Integrated Plant Safety Assessment Systematic Evaluation Program

Millstone Nuclear Power Station, Unit 1

Docket No. 50-245

Draft Report

Figure V-11.A-1 Reactor Water Cleanup System: Suction Line High Pressure Section.

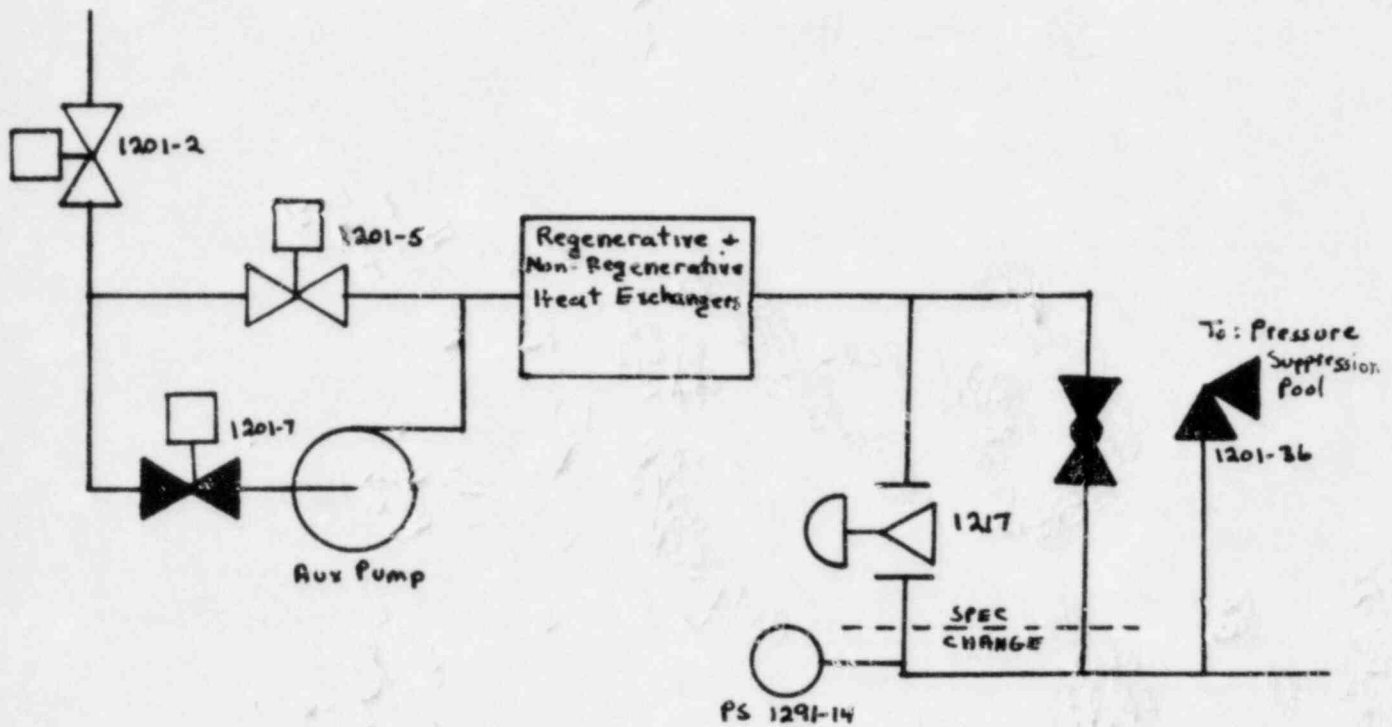
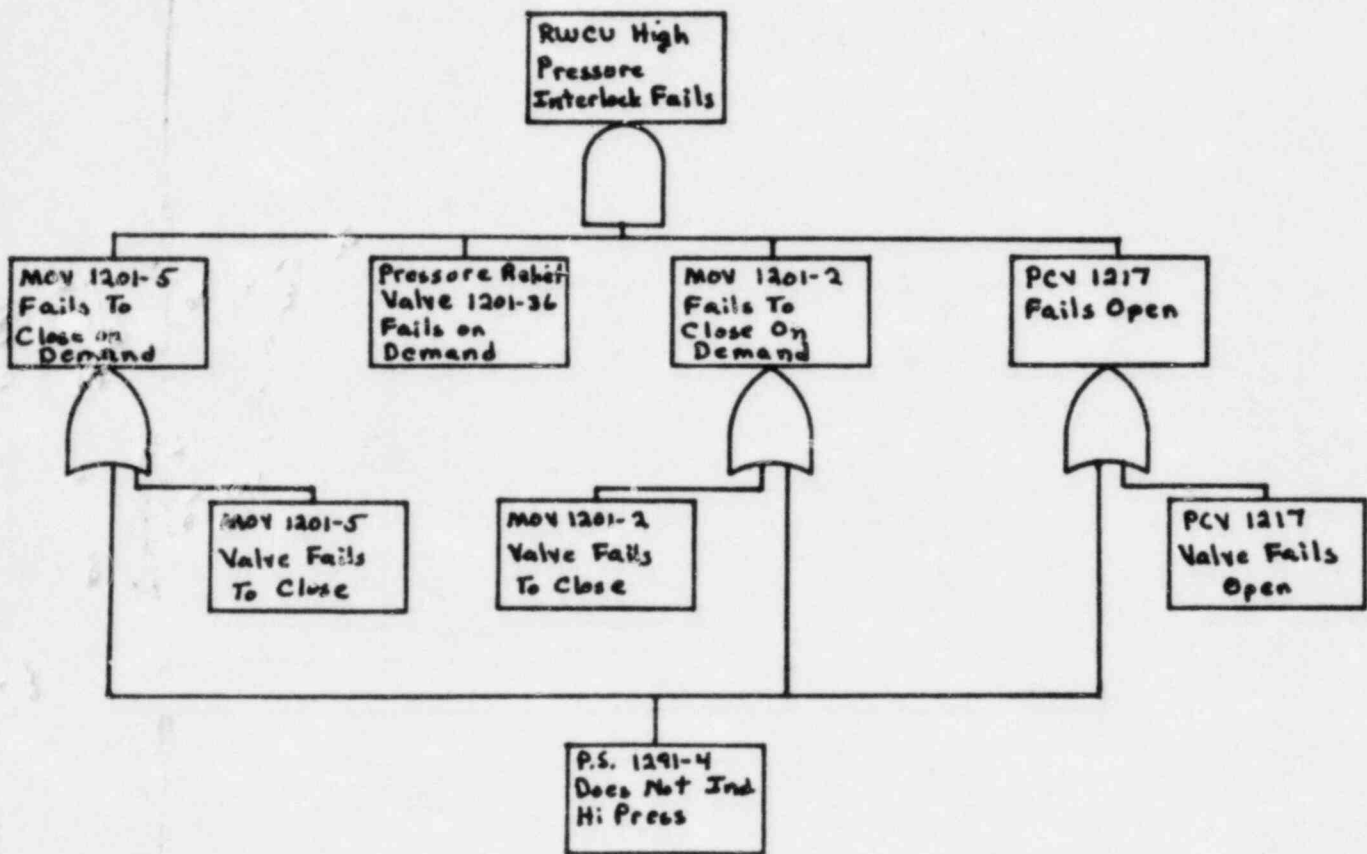
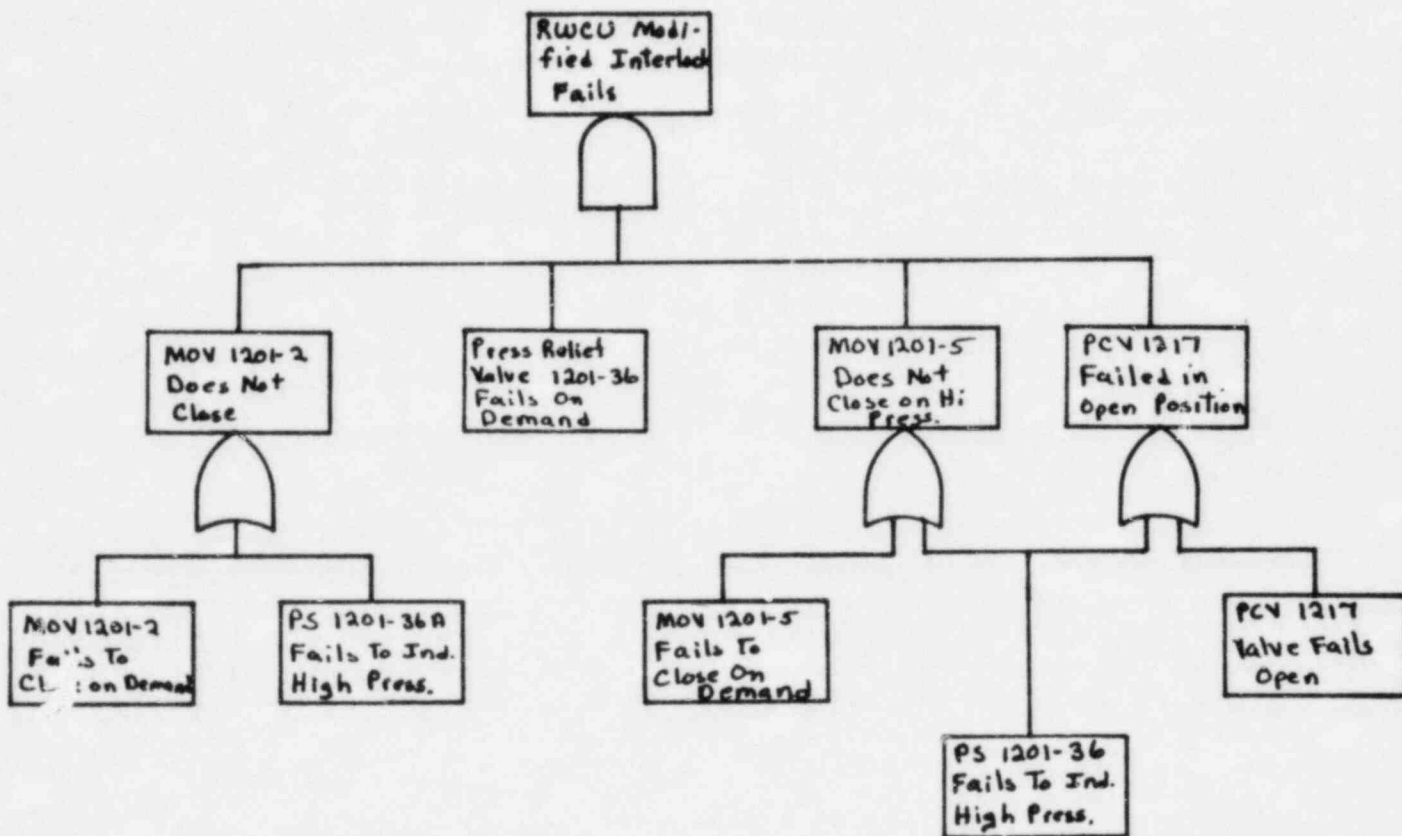
The suction line of the reactor water cleanup system is shown in Figure V-11.A-1 and the fault tree for the failure to isolate on high pressure is shown in Figure V-11.A-2. The two motor-operated isolation valves and the pressure control valve all operate on a single signal from one pressure sensor. (The isolation valves also close on other conditions: low flow, high temperature, etc. However, the pressure signal is the only signal of interest for this analysis.) In Figure V-11.A-1, only the equipment that can be used to isolate the reactor water cleanup system is shown.

A modified design for the high pressure interlock would utilize a second pressure sensor to control one of the two isolation valves. A modified fault tree for this system arrangement is shown in Figure V-11.A-2. From this fault tree the frequency of a high pressure interlock failure in the reactor water cleanup system is $6.8E-9/\text{Ryr}$.
